in, probably observed with the no need half the
 GOLD SCHMIDT RUDDER SUGGESTED REPAIR WHERE WELDING AT SHELF PLATE IS DEFECTIVE.
 planing the lower part of the rudder with the no
 SCALE: 1/2" = 1 FOOT.
 with the rudder with the no need half the
 rudder of the rudder with the no need half the
 rudder of the rudder with the no need half the
 rudder of the rudder with the no need half the

SHIPLEY COX & COMPANY
 ENGINEERS & SHIPBUILDERS
 CONTRACTORS TO
 H.M. GOVERNMENT
 BOILER MAKERS & FOUNDERS
 FALMOUTH, ENGLAND

Lloyd's Register
 Foundation
 S.O. 5815

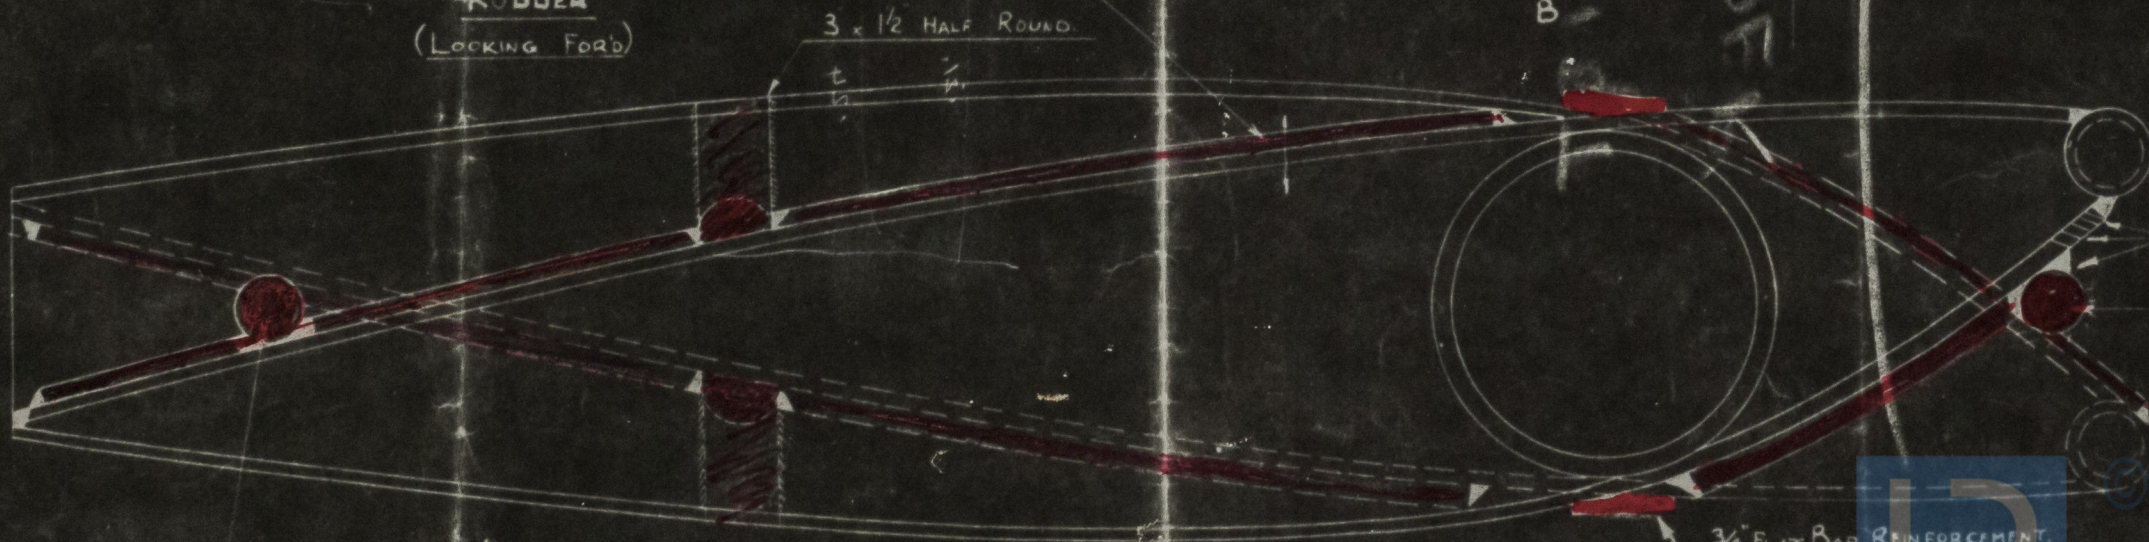
NOTE: IN MANY CASES IT IS FOUND
 THAT THE SIDE PLATES HAVE NOT
 BEEN WELDED TO DIAPHRAGM OR CENTRE
 STOCK. IN SUCH CASES SLOTS 3" LONG
 AND ABOUT 6" APART SHOULD BE CUT
 IN THE SIDE PLATES TO ALLOW WELDING
 TO THE INTERNAL STRUCTURE.

3 SOLID ROUND.
 CONTINUOUS THROUGH AND
 WELDED TO SHELF PLATE.
